VISUAL SITE INSPECTION REPORT – 2019

**SOUTHERN INDIANA GAS AND ELECTRIC
A. B. BROWN GENERATING STATION
TYPE III RESTRICTED WASTE LANDFILL
WEST FRANKLIN, IN**

ATC PROJECT NO. 170LF00789

Drawing Title:
 SITE PLAN
 TYPE III RWS LANDFILL
 8511 WELBORN ROAD
 MOUNT VERNON, INDIANA 47620

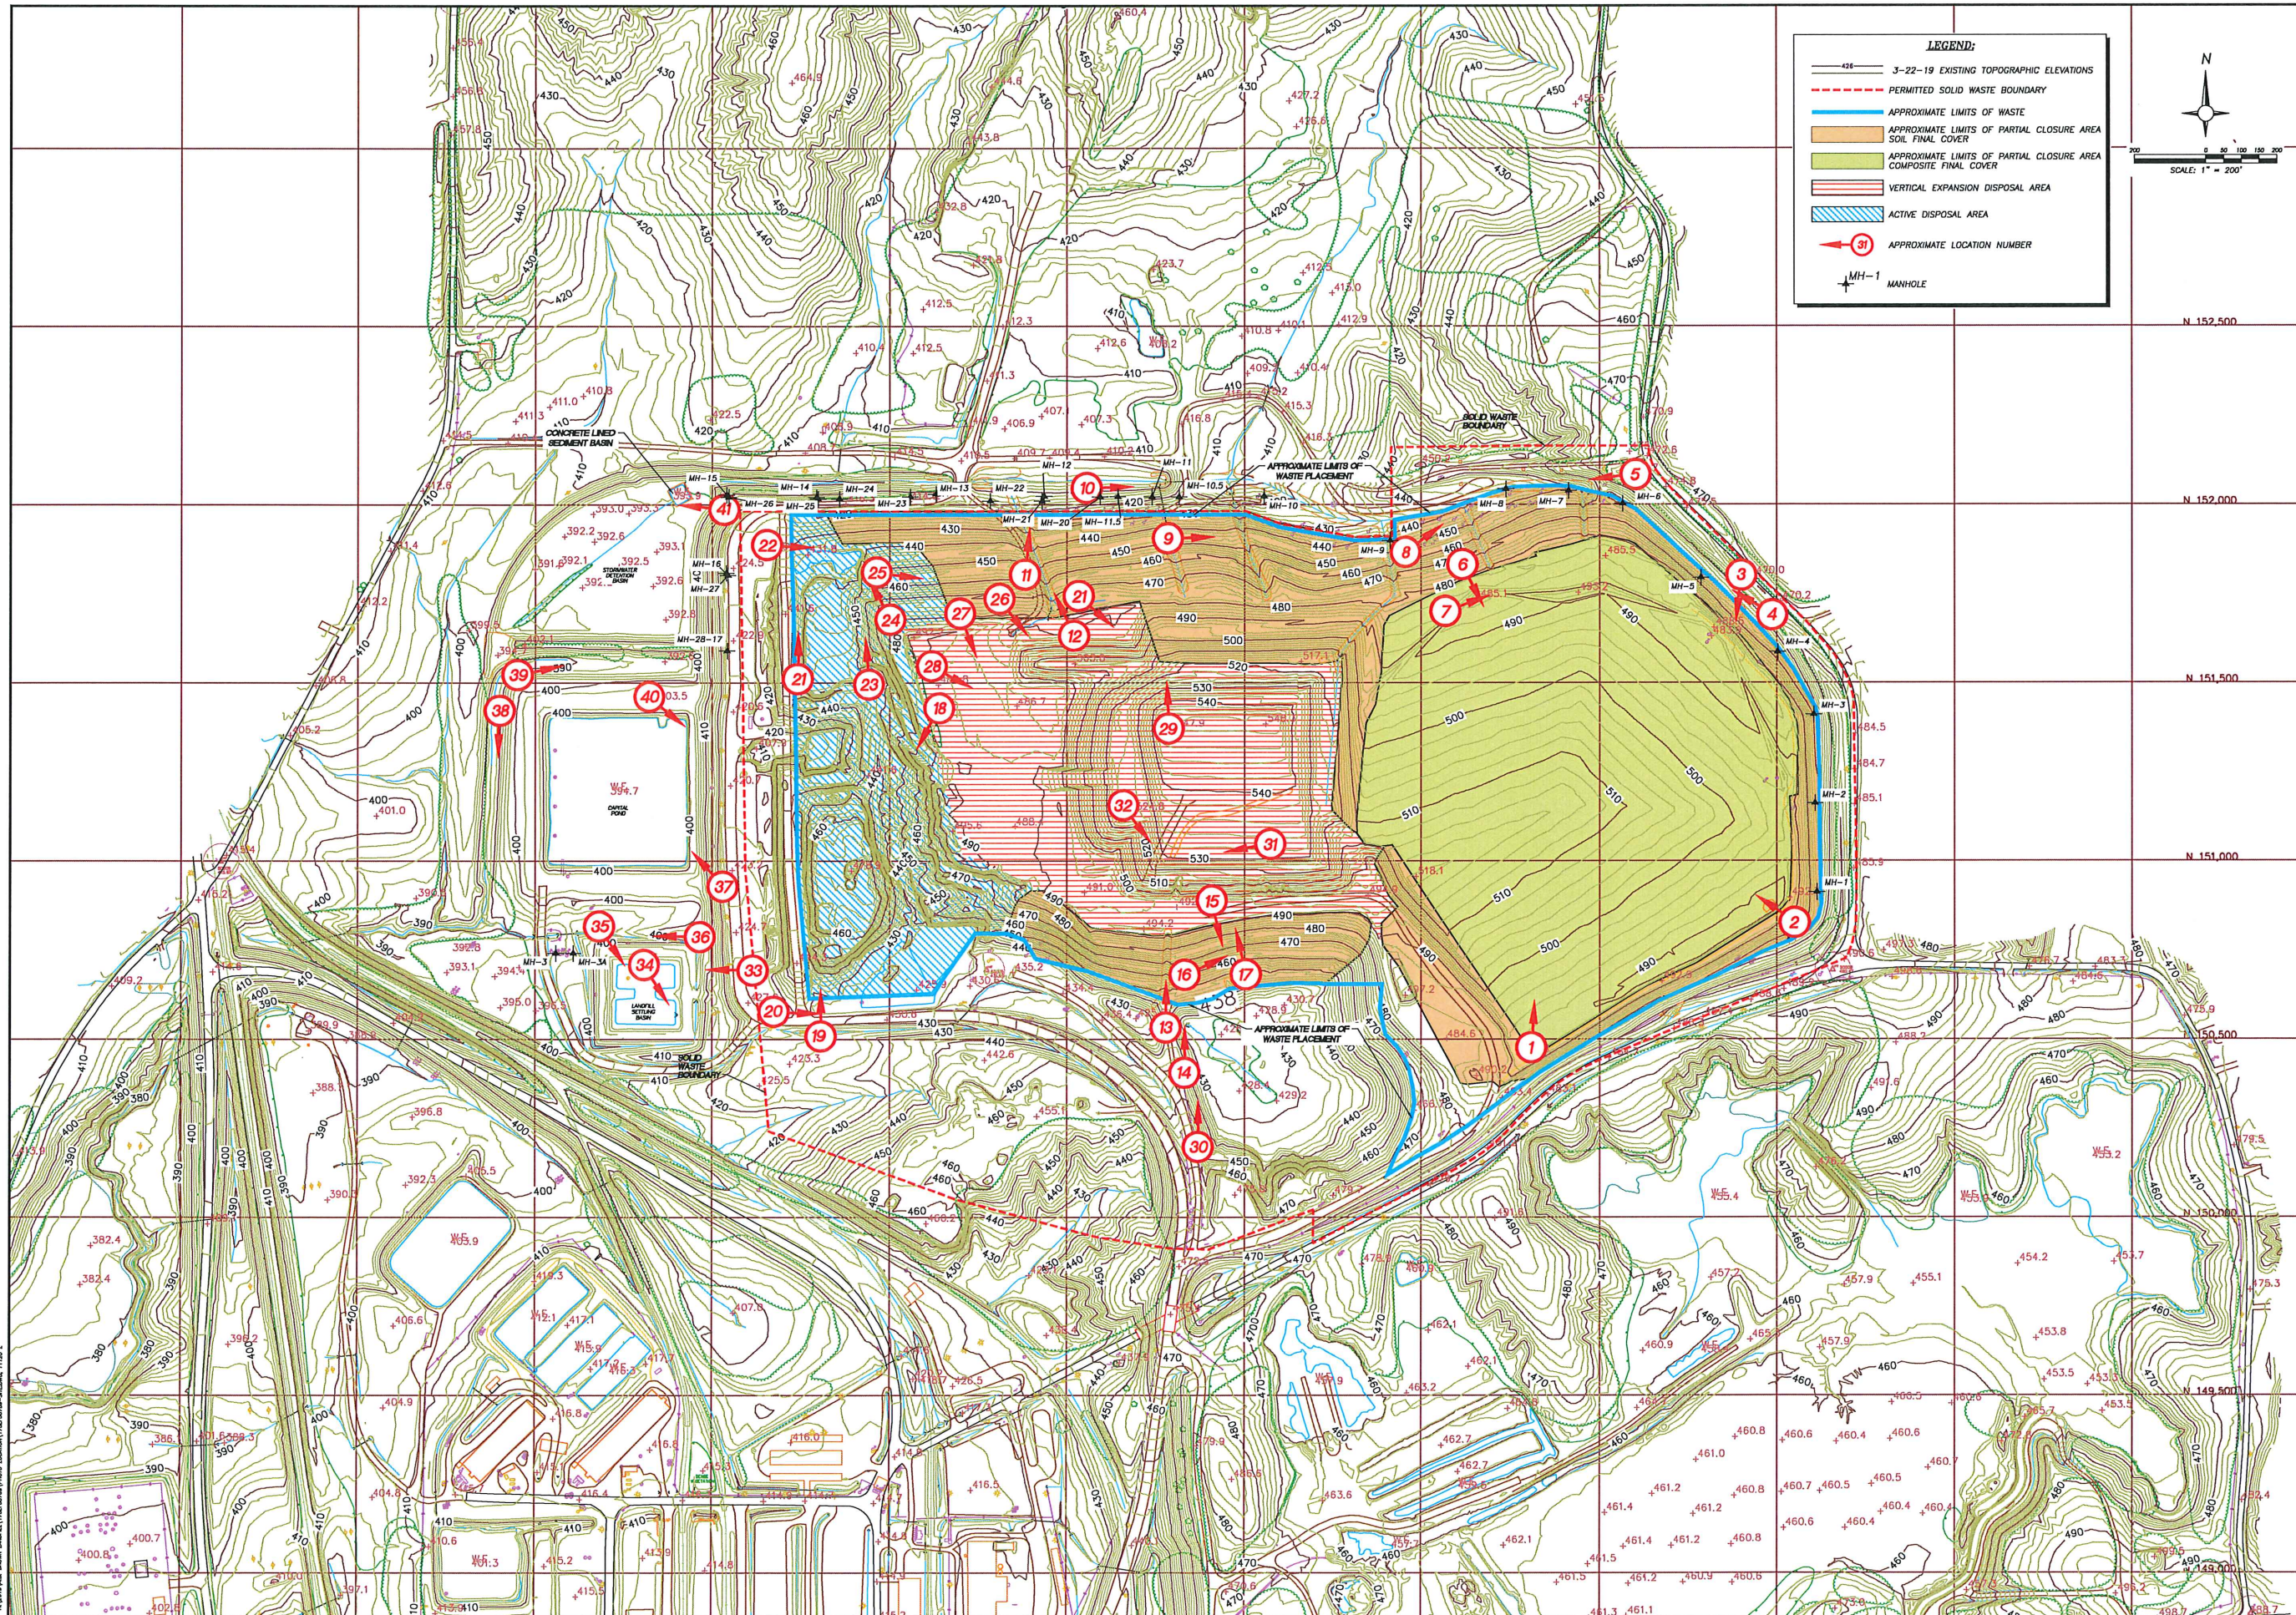
- 4) On the north side of the Composite Final Cover Area, one of the four drop inlets present has become clogged with vegetation debris (Locations 6 and 7).

- 5) A seep is present on the north slope near the east end of the landfill. A trench has been excavated in the area to collect the seep water and convey it in pipes to the Capital Pond. It is our understanding that the flow rate varies seasonally and that the peak rate continues to decrease following the construction of the composite final cover across the top of the east end of the landfill (Location 8).

- 6) Observations made during the site visit indicate that Manholes 1 through 6, 8, 9, 10.5, 11, 11.5, 12, 20 and 21 are flowing without significant obstruction. Based on water levels noted in Manholes 7 and 10, some blockage appeared to be present at those locations at the time of the inspection. Maintenance was being performed to remove the blockage from Manhole 10 at the time of the inspection (Location 9).

- 8) The inspection noted filter cake in the drainage ditch north of the north slope of the landfill outside of the Solid Waste Boundary (Location 10). At the time of this inspection, there was no evidence to indicate migration of waste beyond the property boundary.

- 9) The riprap in a downchute near the west end of the north slope has been displaced at several locations, including one area where the geotextile underlying the riprap is now exposed (Location 11). A significant amount of soil sediment was also noted in the riprap (Location 12) and in the drainage ditch that receives discharge from that downchute. Site personnel indicated that the displacement of the riprap and deposition of the soil sediment occurred as the result of a recent significant rain event. Based on field observations, it appears that the drainage area that is now discharging to this downchute increased significantly as a result of the 2019 filling operations in the vertical expansion area. It appears that this downchute was not designed to accommodate this additional discharge.

- 11) The inlet of one of the downdrain pipes, which conveys water from one of the drainage terraces on the south slope is partially clogged (Location 15). Further, a subsidence feature was noted along the pipe alignment (Location 16) and the pipe has been damaged near its outlet (Location 17).

- 2) There is a limited amount of freeboard between the surface of the waste and the adjoining access road at the south end of the Active Landfill Area (Location 20). In addition, surface water runoff from the northern portion of the Active Landfill Area is routed to a depression with limited freeboard at the far north end (Locations 21 and 22).

- 3) Filter cake has recently been stockpiled at the north end of the active fill area (Location 23). A portion of this stockpile extends onto the cover soils at the west end of the north side of the Landfill Partial Closure Area (Location 24) creating a potential path for filter cake to migrate on to the north slope of the partial closure area (Location 25).

- 1) Filter cake was placed along the western side of the Vertical Expansion Area in late summer/fall of 2019. The newly placed material was covered with soil and vegetated. However, due to an extended dry period that occurred following the seeding the vegetative cover is not well established and therefore significant erosion was noted in multiple areas (Locations 26 thru 31). Repairs were underway at the time of this inspection to fill and reseed the eroded areas and to install some temporary drainage controls, included a diversion berm (Location 32) and a downdrain pipe.

- 2) The 2019 placement of fill in the active fill area created portions of two drainage terraces at the northwest corner of the new fill placement. Both of these terraces are sloped to drain to the west but the recent filling did not extend far enough to install the permanent downchute. As a result, surface water runoff currently flows down either the west or north slopes causing erosion of the recently seeded cover soils (Location 29).

- 2) The southeast portion of the pond has accumulated sediment that may impair the discharge into the pond (Location 34).

- 5) The inspection noted an accumulation of sediment in the northeast corner of the Capitol Pond (Location 40).

- 6) The concrete lined sediment basin located within the detention basin was nearly full of sediment at the time of this inspection (Location 41).

Recommendation: Remove debris to restore the original condition. This drop inlet was also noted to be clogged during the 2018 inspection. It is recommended that the drop inlet be inspected at least quarterly to remove accumulated debris.

Recommendation: Continue to collect and convey the seep water to the Capital Pond.

Recommendation: Continue maintenance of the subsurface drainage system on an as needed basis to ensure the line drains freely.

Recommendation: Remove filter cake from the drainage ditch to help control the migration of filter cake outside of the Solid Waste Boundary and continue proactive maintenance of stormwater controls.

Recommendation: Re-establish the riprap protective layer in the downchute as soon as practical to try to avoid further damage to the downchute. An analysis should be performed to modify the temporary stormwater controls to either divert a portion of the

drainage area to a different outlet pipe or channel, or provide some detention to reduce the peak flow to the downchute.

Recommendation: The debris should be removed from the pipe inlet and the eroded area near the outlet should be revegetated. Further, the downdrain pipe should be repaired and the subsidence area backfilled.

Recommendation: Monitor these areas during significant storm events to avoid the release of filter cake. Consider regrading the areas to provide additional storage capacity for stormwater runoff and/or add a soil berm to increase freeboard in these areas.

Recommendation: Regrade the filter cake stockpile to ensure that all runoff from the pile is contained within the active fill area to prevent filter cake from migrating outside the Solid Waste Boundary.

Recommendation: Complete the repairs that are currently underway. A drainage analysis should be performed to determine the need for additional temporary drainage controls to include the diversion or detention of a portion of the drainage that currently discharges to the riprap lined downchute on the north slope of the partial closure area (discussed above).

Recommendation: Temporary stormwater controls should be designed and installed to control discharge from the partially completed drainage terraces.

Recommendation: Remove accumulated sediments as needed to maintain the pond capacity.

Recommendation: Remove the sediment from the basin and place it in the landfill.

Recommendation: Remove the sediment from the basin and place it in the landfill. Monitor the basin and remove sediment once the basin is approximately half full to help minimize the potential migration of filter cake into the detention basin.
